UNITED STATES PATENT AND TRADEMARK OFFICE

APPLICATION NO.	FILING DATE	FIRST NAMED INVENTOR	ATTORNEY DOCKET NO.	CONFIRMATION NO.
10/798,779	03/12/2004	David G. Filippi	COLME-0004	5631

Office Action Summary

DETAILED ACTION

FIG. 3

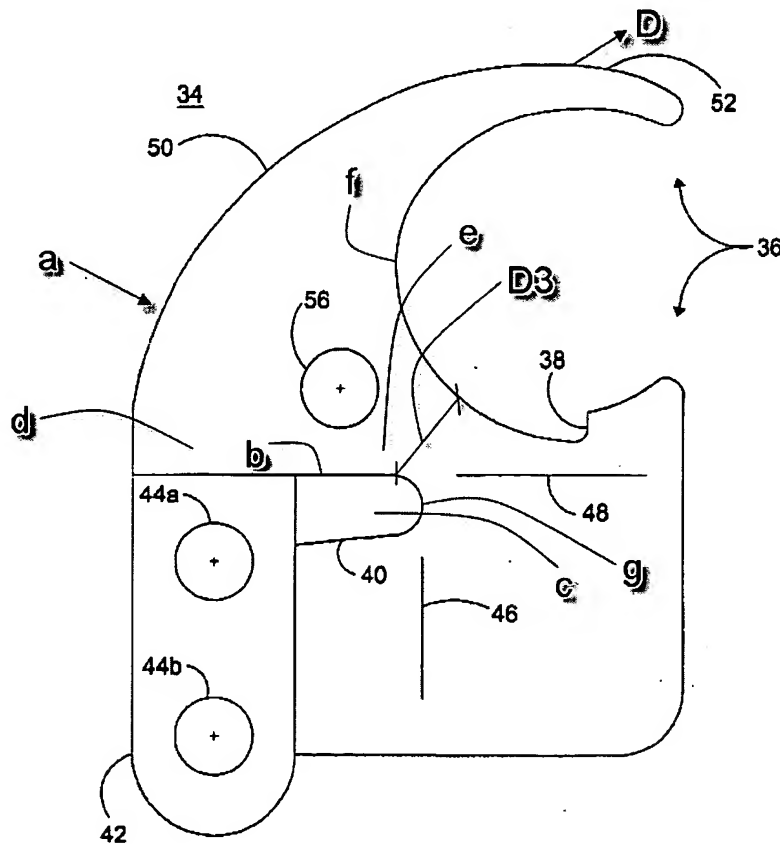
Regarding claims 45 and 65, Stevens in Figures 2 and 3 discloses a gutter-cover system for spacing a wall (20, 22, 24) of a gutter (4) from a gutter cover (2) comprising a solid sheet (2) having one longitudinal edge thereof formed into a curl (12) and wherein the cover (2) extends downwardly and outwardly from the lowermost edge of a roof (8) so that said curl (12) extends downwardly toward said gutter (4); a gutter-cover clip (34) having a substantially flat body portion (a) inherently having a thickness; said body portion (a) comprising a first throat portion (36) having first (52) and second (38) jaws thereof and shaped so that said first throat (36) portion is adapted to engage said curl (12) of said cover (2); third (b) and fourth (e) jaws and a second throat (c) located therebetween, said second throat (c) being adapted to engage said wall (22, 24) of said gutter (4) between said third (b) and fourth (e) jaws; and, at least a first locking lever (d) adjacent said third jaw (b) and joined to said body (a) portion by a hinge (e), said first locking lever (d) being adapted to be bent at said hinge (e) to bring said third jaw (b) into a locking position against said gutter (4) as seen in Figure 2.

Regarding claim 55, Stevens in Figure 2 discloses a gutter-cover system wherein said clip (34) is adapted to lock onto a gutter wall portion (22) and wherein said third (b) and fourth (40) jaws are essentially parallel to said gutter wall (22).

Regarding claim 62, Stevens in Figures 2 and 3 discloses a gutter-cover system wherein the deepest part (f) of said first throat (36) and the deepest part (g) of said second throat (c) lie essentially in a common plane.

Doussot et al. (U.S. Patent No. 5,426,832)

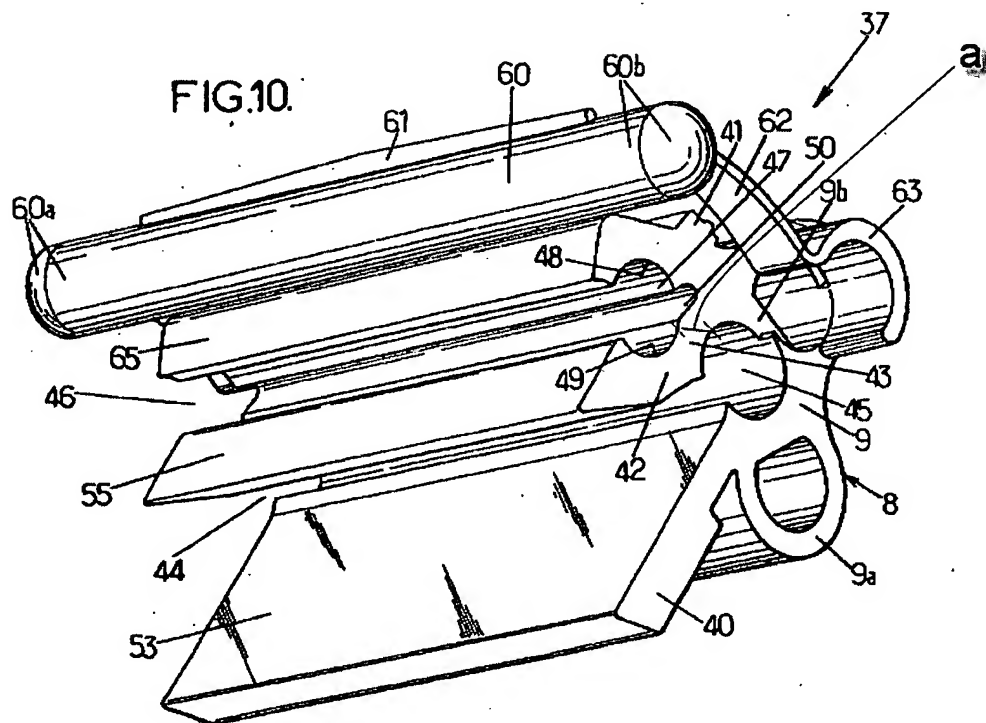
Regarding claim 43, Stevens discloses a gutter-cover system as discussed above but does not disclose a gutter-cover system further including a bending slot in said body portion, said bending slot being located above said second throat so that said hinge is between said second throat and said bending slot and having a width (D3) whereby a force applied to said bending slot moves said locking lever about said hinge so that said third jaw is brought into locking engagement with said wall of said gutter. However, Doussot et al. in Figures 10 and 13 discloses a fixing clip including a bending slot (46) in a body portion (37), said bending slot (46) being located above a second throat (45) so that a hinge (43) is between said second throat (45) and said bending slot (46) and having a width (a) whereby a force applied to said bending slot (46) moves a locking lever (55) about said hinge (43) so that a third jaw (57) is brought into locking engagement with a rod (4). Stevens and Doussot et al. are analogous art because they are pertinent in the problem of securing a member via a clip. Therefore, it would have been obvious to a person having ordinary skill in the arts at the time of the applicant's invention to modify the clip of Stevens to include a bending slot in said body portion,

said bending slot being located above said second throat so that said hinge is between said second throat and said bending slot and having a width (D3) whereby a force applied to said bending slot moves said locking lever about said hinge so that said third jaw is brought into locking engagement with said wall of said gutter as taught by Doussot et al. to further clamp down on an object that needs to be secured, in this case, the gutter wall (Col 10, Ln 3-17).
